# Comment 205: Figure 201-7 and Related Comment 46: Figure 201-11

G. Zimmerman / CME Consulting

Revised 3/5/2026

Figure 201-7—HS\_TX PCS Transmit function block diagram

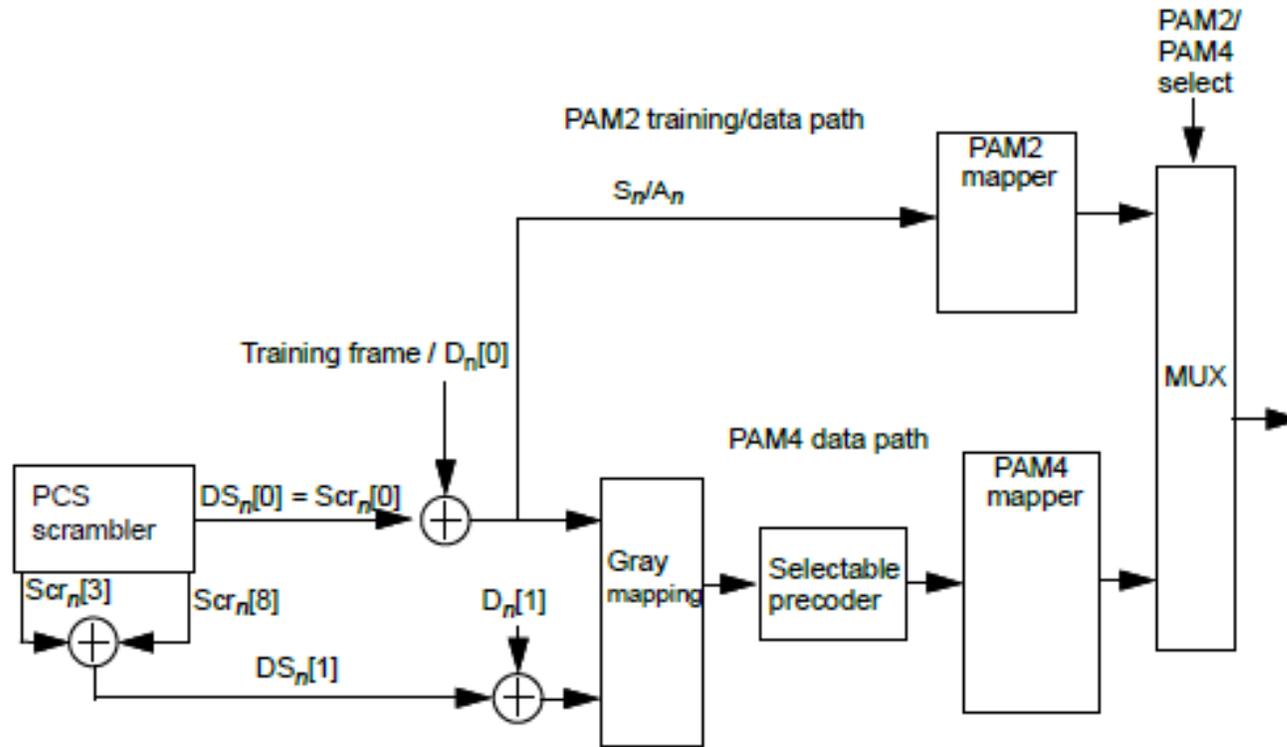
Existing Figure 201-7 has a number of issues.

- It mixes 2.5G/5G and 10G PCS features, which are different (2.5G/5G does not have the PAM4 path at all...),
- It is missing interfaces where signals come from
- The output is not labeled to reference other diagrams
- The Figure claims to be a 'block diagram' of the PCS Transmit, but is really only a subset of the PCS Transmit, and omits the RS-FEC encoder, and the PCS Transmit process which generates the 65B blocks from XGMII

Figure 201-7a—10Gbps HS\_TX PCS Transmit function block diagram

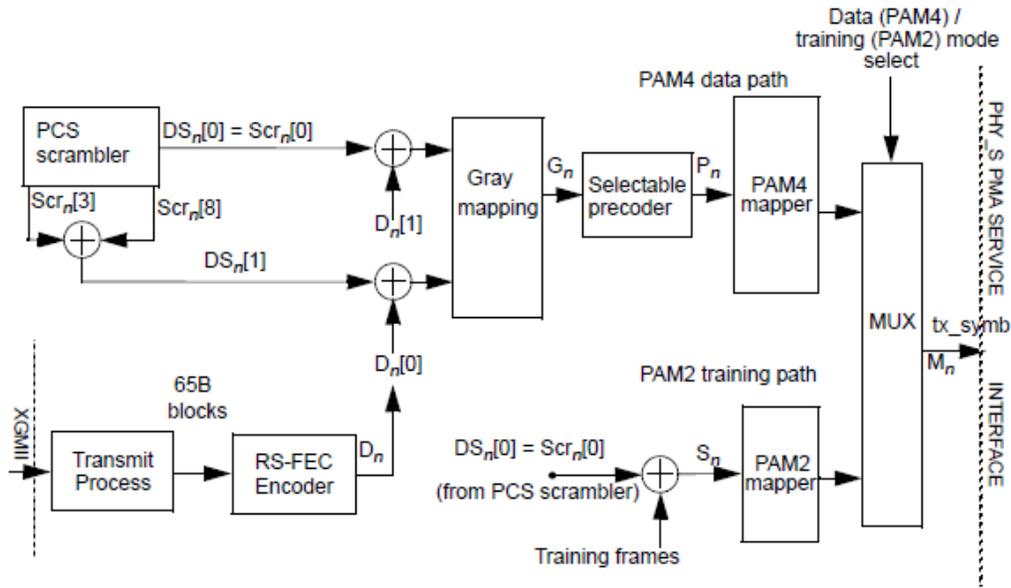
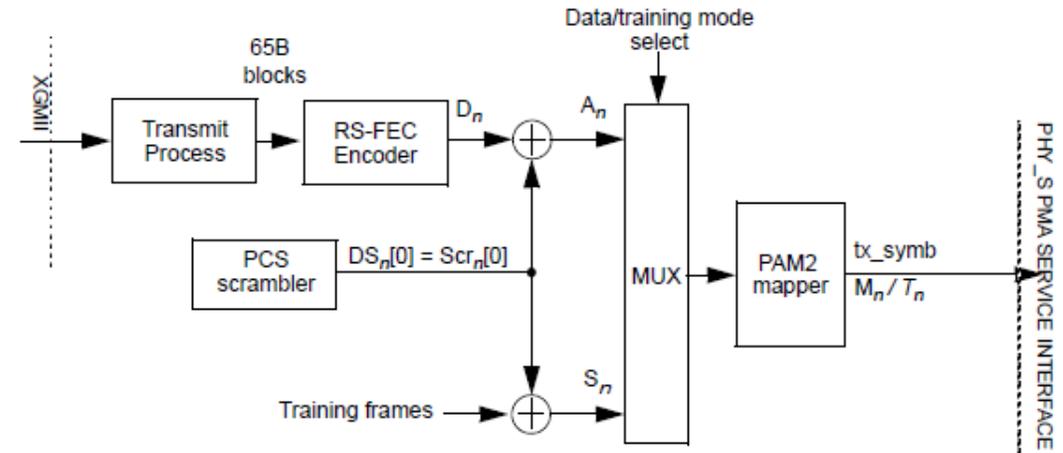
The block diagram of HS\_TX PCS Transmit functions is shown in Figure 201-7a and Figure 201-7b, replacing Figure 149-5. .

NOTE —The  $S_n$  are from the training frame, and the MUX selects the PAM2 path while in PAM2 training states.

NOTE 1 —The  $S_n$  are from the training frame, and the  $A_n$  are for the 2.5G and 5G HS\_PATH.  
NOTE 2 — The output of the PAM2 mapper is  $M_n$  in data mode and  $T_n$  in training mode.

Figure 201-7b—2.5Gbps and 5 Gbps HS\_TX PCS Transmit function block diagram

Figure 201-11—PCS Transmit function block diagram for low speed path

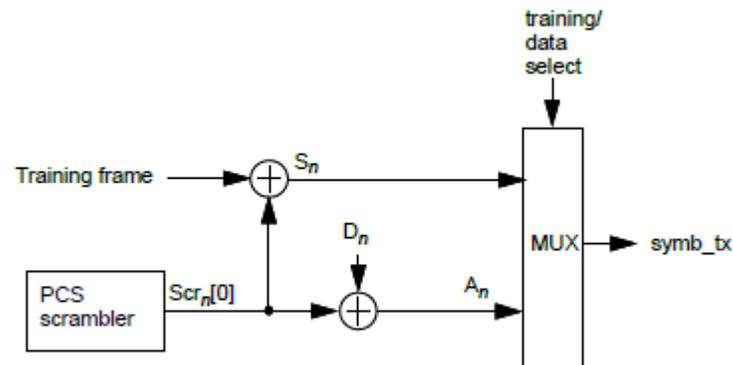
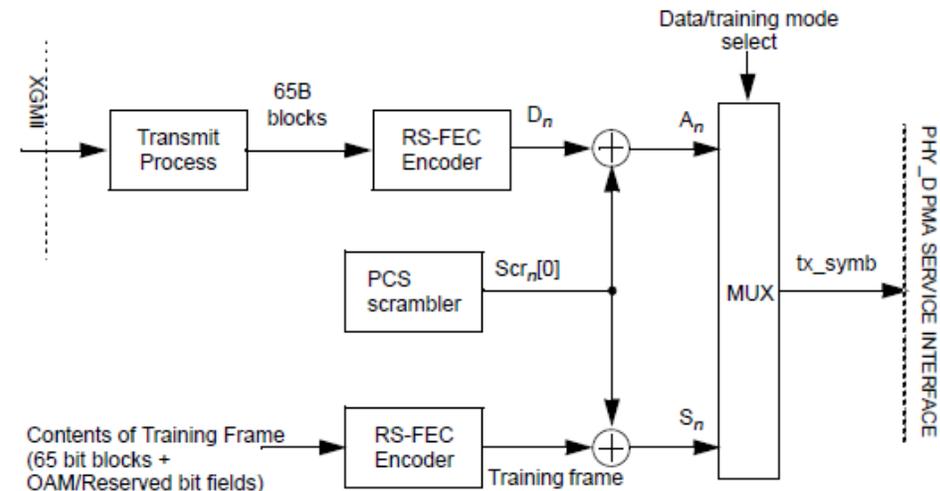
ID	Commenter	Affiliation	Subclause	Page	Line	Comment	Suggested Remedy
46	Jonsson, Ragnar	Infineon	201.4.2.3	97	32	HS_PATH in Figure 201-7	Change the handling of the "Training frame" in the figure to be consistent with how it is done in Figure 201-7

A block diagram of the low speed path PCS Transmit functions is shown in Figure 201-11.
